ADDENDUM NO. 2

Date: 04/24/2023

**Project: Project #: 0530-434
Luther Burbank High School Core Academic Renovation, Phase 2**

DATE: 09/27/20 CLIENT PROJ NO: 3156068100

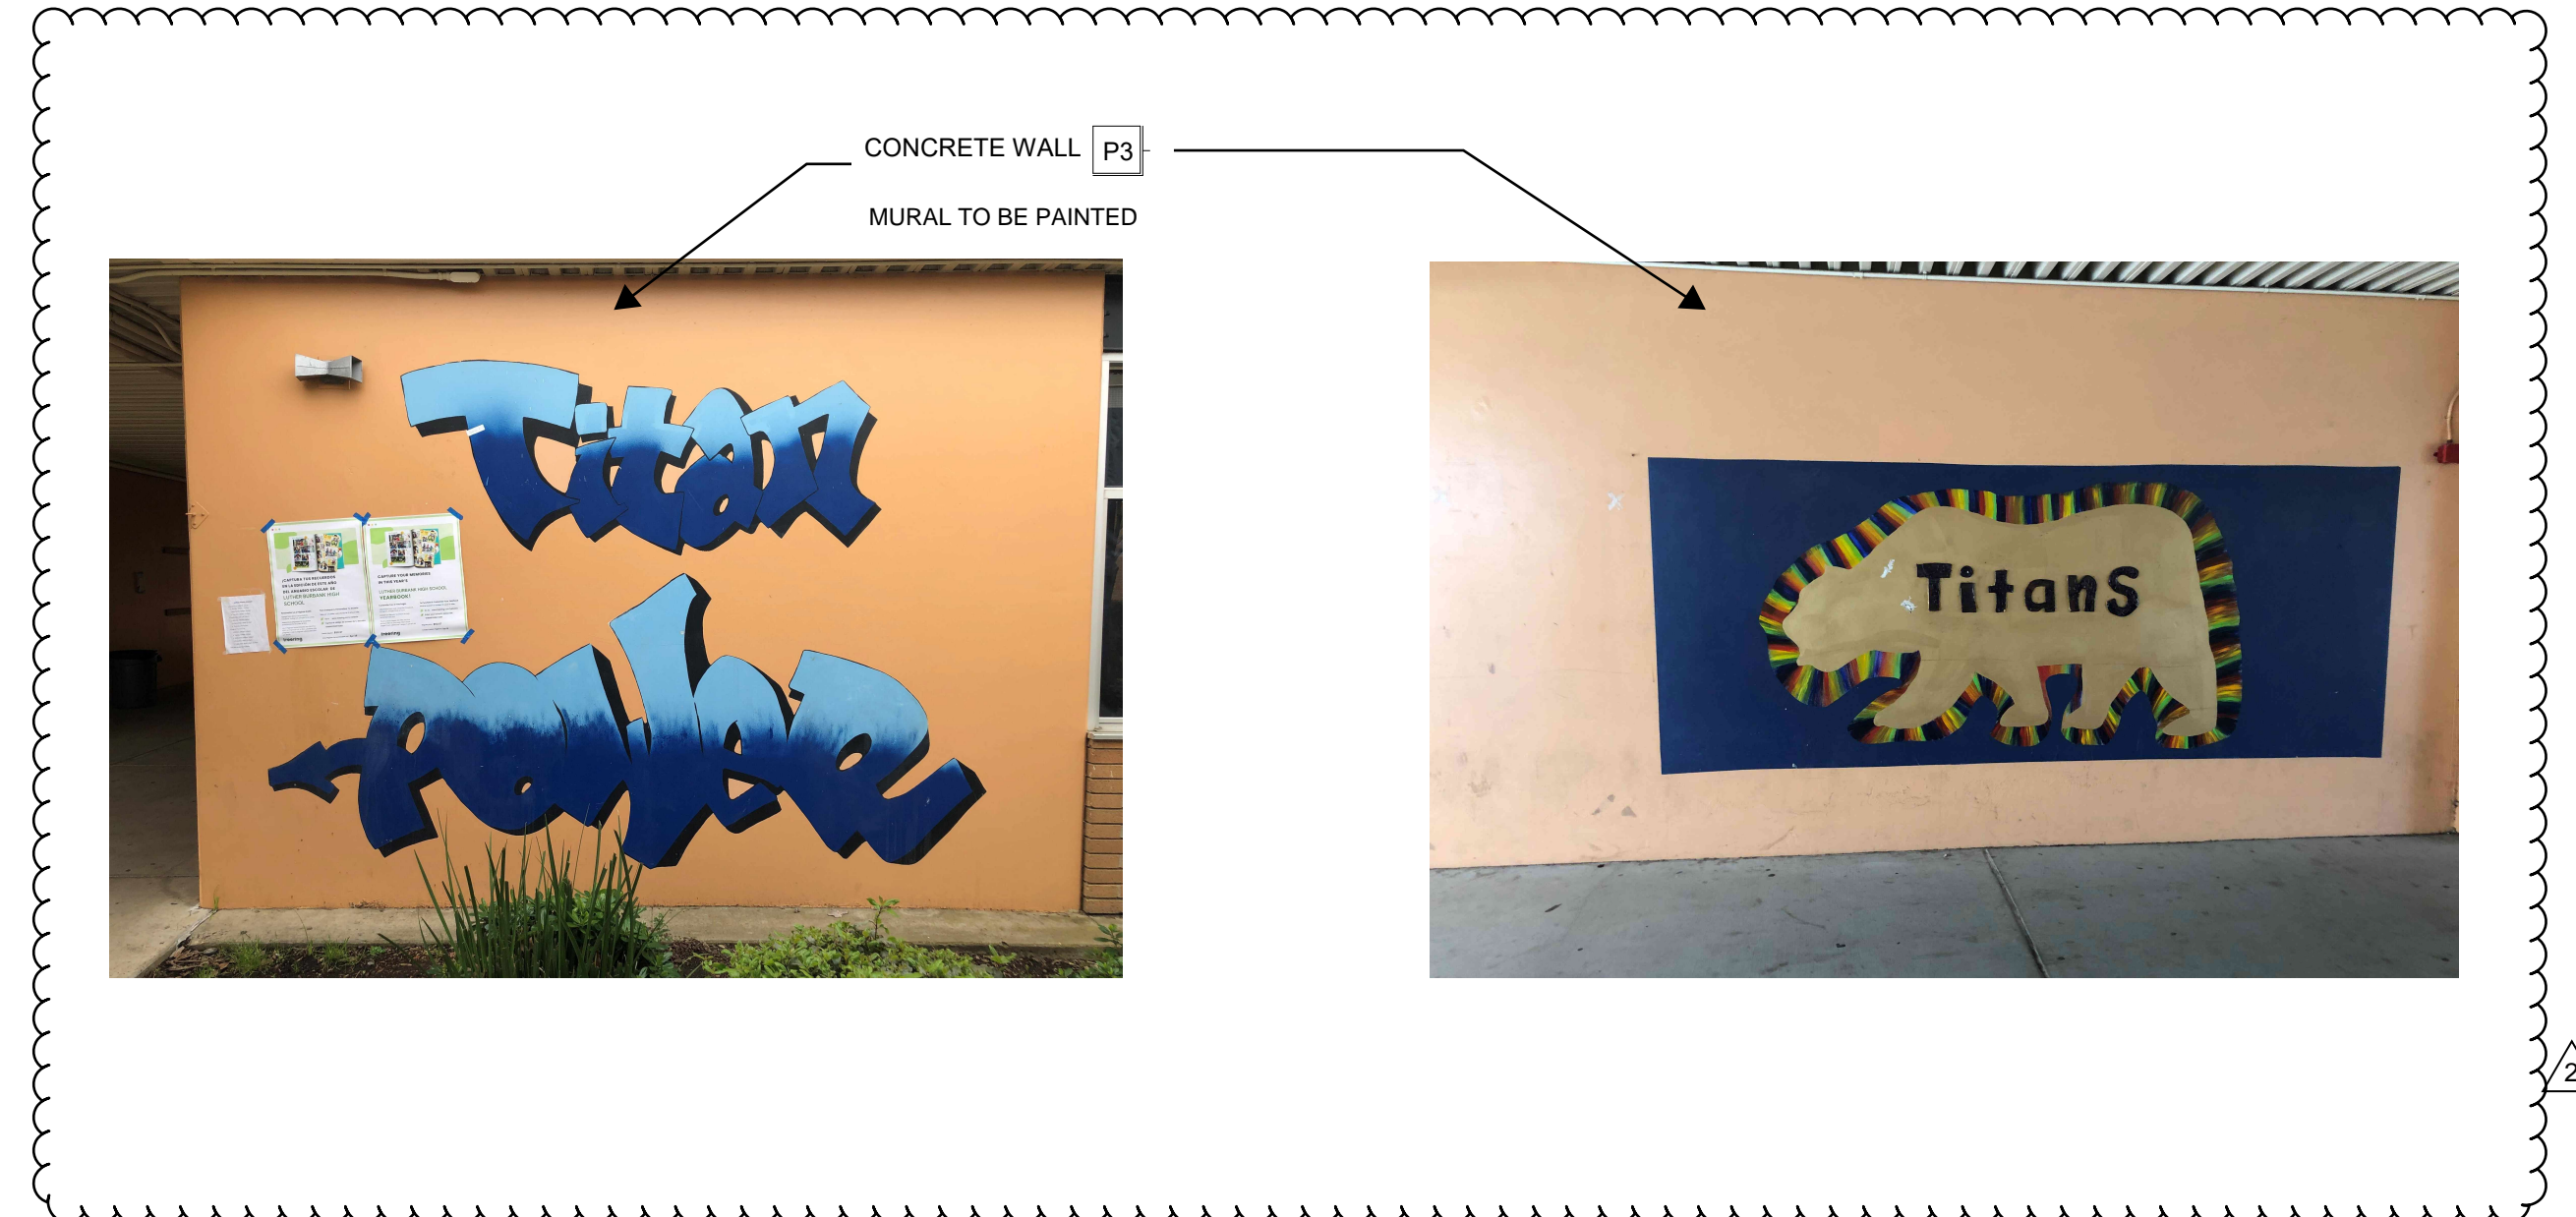
Delete drawing A1.12 and replace with the drawing AD2.1 Enlarged Site plans dated 07/25/10.

A2.30
AD2.2

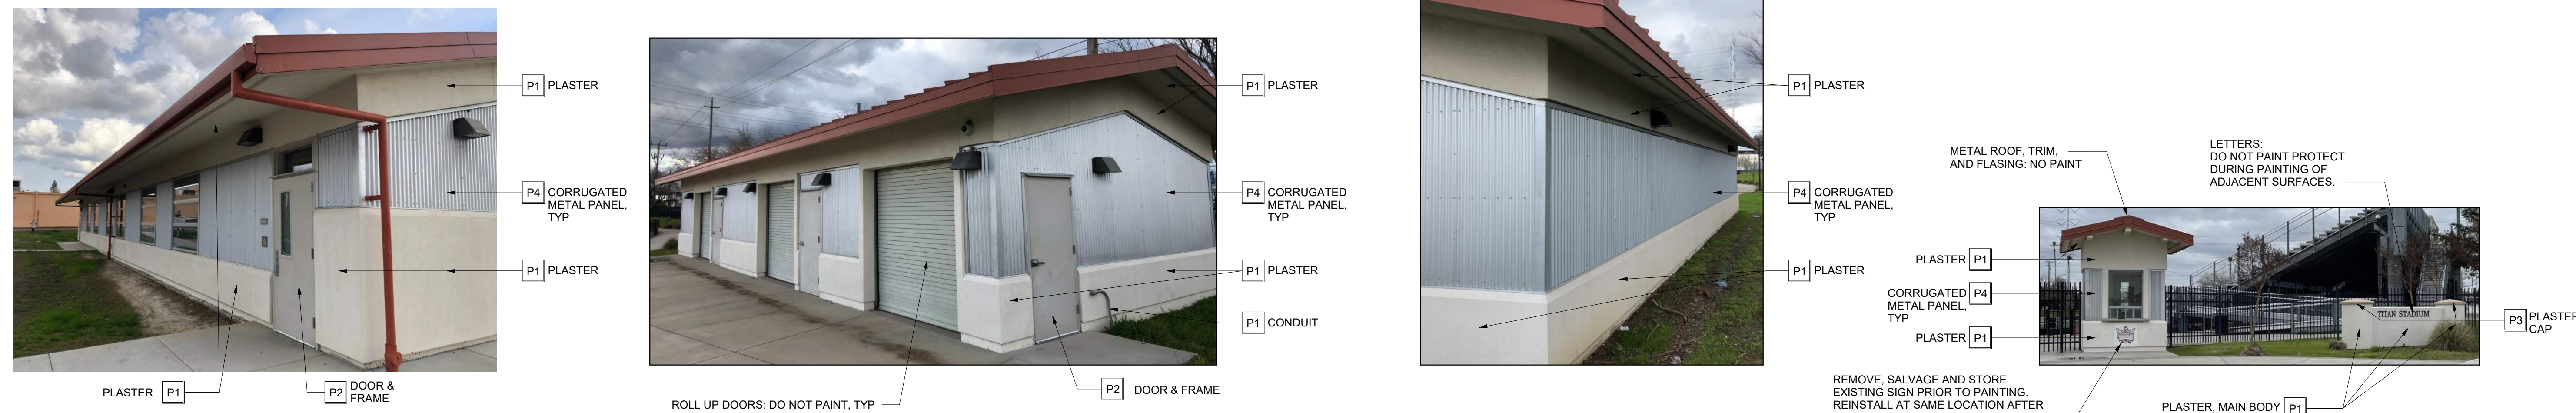
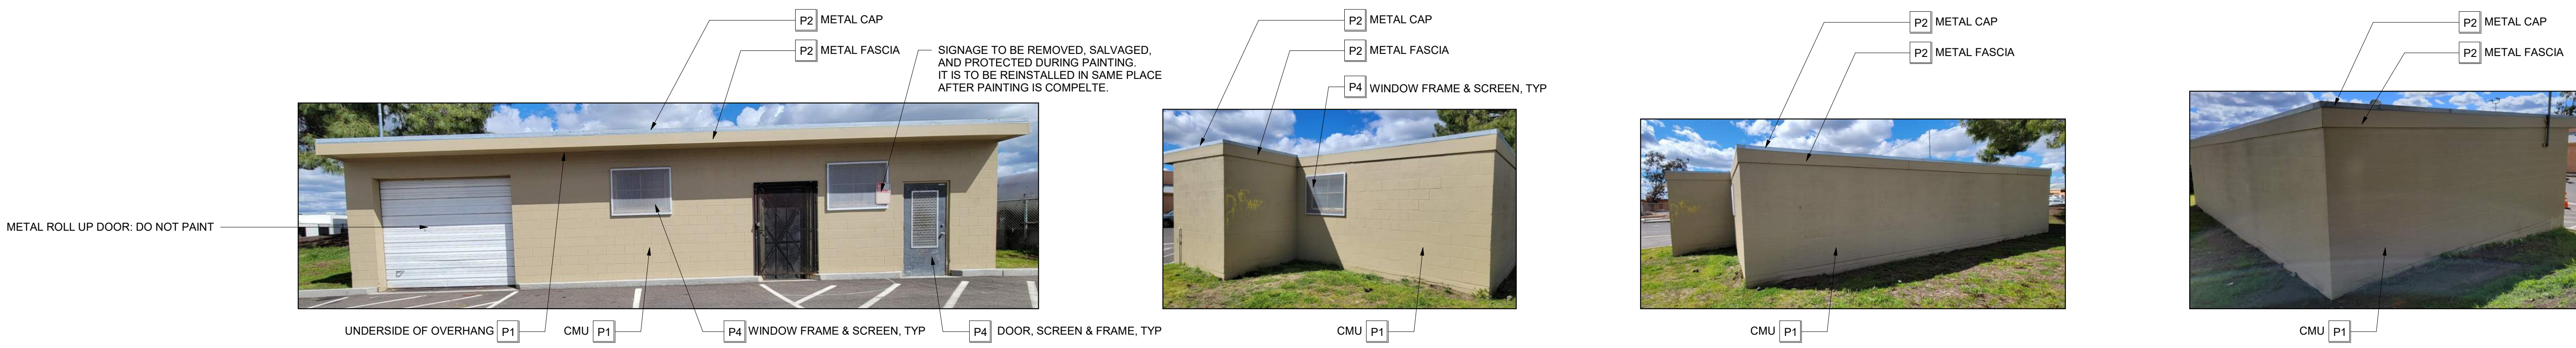
Delete drawing A2.30 and replace with the drawing AD2.2 Exterior Elevations dated 7/25/10.
